345 MV
n°

Technical Information

Subject: **Retention strip addition**

Product: **LXP 950 Orioli \ Enduro Veloce**
All affected VINs are linked in Dealer.net

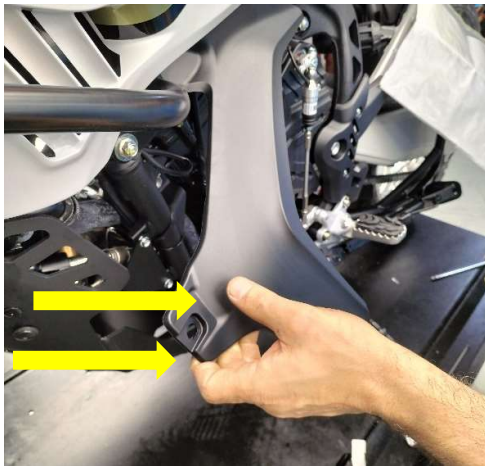
- Remove the two fixing screws of the left engine cover code. SPMV8000D3223:

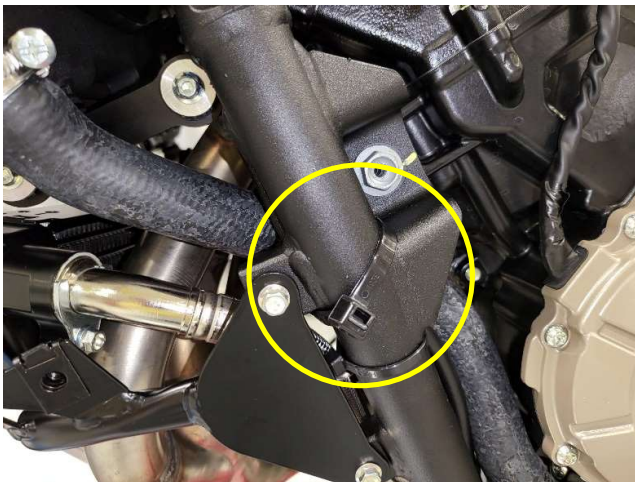
- Collect the retaining clamp cod. SPM
- V8000C6415 and separate the clamp from the receptacle for the screw, **the removed part will not be used.**

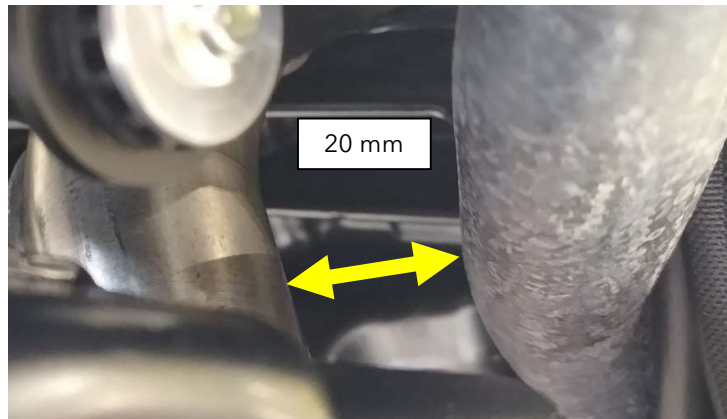
- Apply the clamp between the left cradle of the frame and involving the coolant pipe cod. SPMV8000D1694; **the clamp must take the electrical cables present in the area, NOT the oil pipe.**
The clamp must be passed through the hole present on the fixing slot of the cradle (right side pic):

- To ensure correct tightening of the clamp it is possible to use an 8 mm Allen key as a template by inserting it into the clamp and pulling it until it comes into contact with the tool; **NOTE: DO NOT FORCE beyond the contact point, pull lightly until the band has slightly tightened the sleeve.**
